Subject: Re: Hunt APO State No. 1 (1RP-4891 and 4892)

EOG RESOURCES LEA COUNTY, NEW MEXICO HUNT APO STATE No. 1

SAMPLE LOCATION MAP

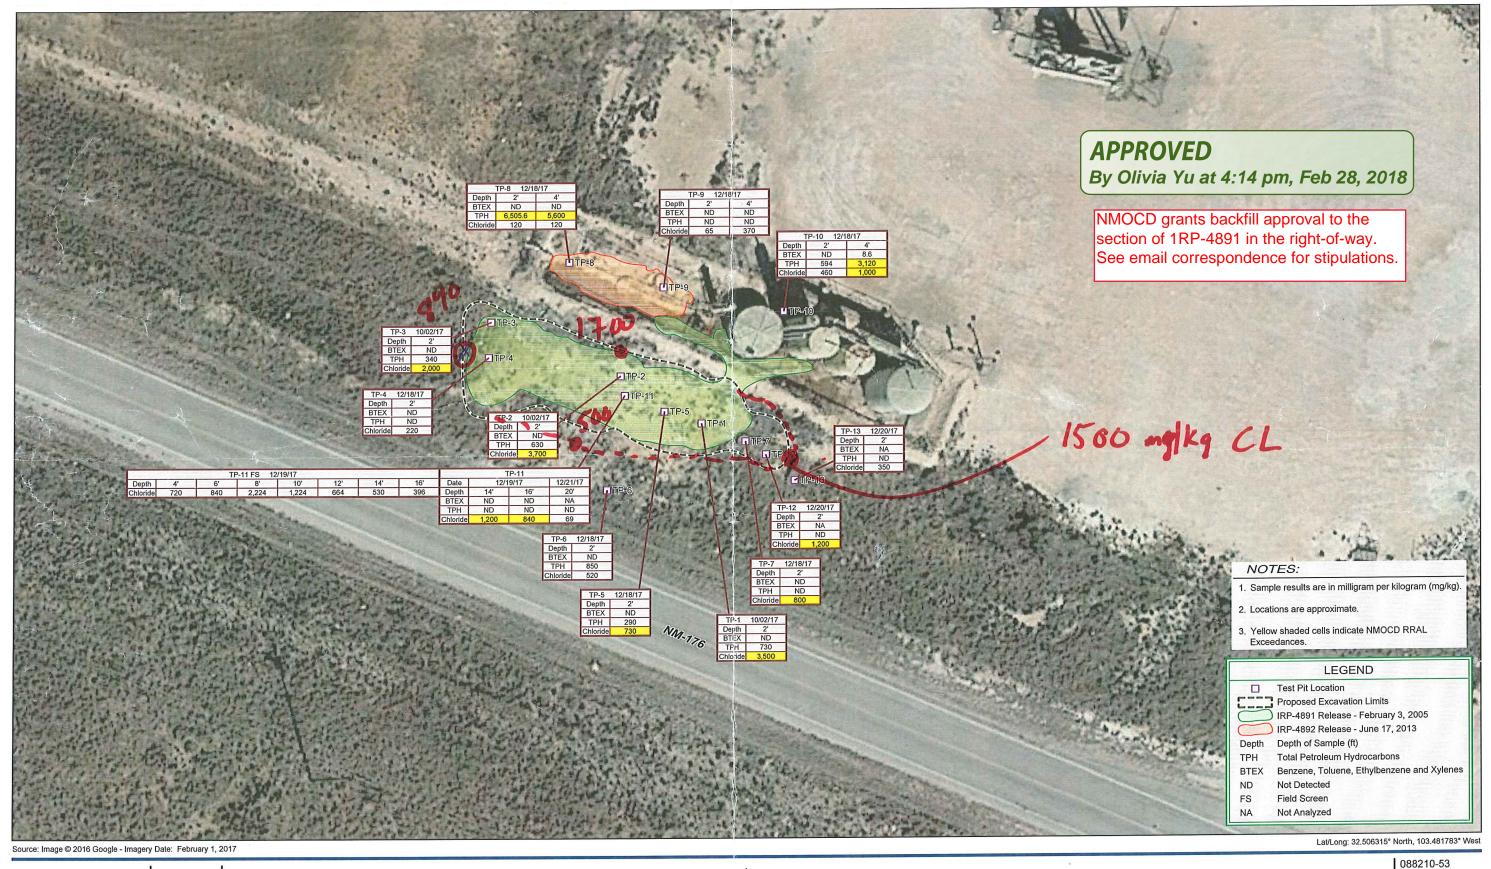
After further discussions with Michael, he said that the 2' deep excavation extends past TP-13 to the east a little ways. The sample he collected with the 1,500 mg/kg was from west of TP-13. Based on this, we are good to the east. So we can line the whole excavation and backfill. We will remove the soil on the north side when we do the pad area. Are you OK with this?

possible to remove this last strip between the current East sidewall and TP-13 to 2 ft. bgs during the backfill process? As much as possible in depth to promote vegetation?

Here is a drawing showing the sidewall samples for Hunt. The chloride concentration on the west side exceeds the RRAL and there is an overhead power line preventing further excavation in that direction. The north sample was collected next to the berm and we can excavate that soil once the lines are moved and we start working in the pad area. The sample to the east is also above the RRAL but TP-13 just a litter further east is below the RRAL. Since the caliche is so hard to excavate and they really couldn't go deeper than 2 feet in that area, can we leave that small amount of impacted soil in place? We would really like to line the excavation and backfill it as soon as possible since it is in the highway right-of-way which poses a danger. Please let me know what you think.

Confirmed. Just make sure to outline the section excavated to 4 ft. bgs and the section 2 ft. bgs. on a map with GPS coordinates. North sidewall to be addressed with 1RP-4892 is noted.
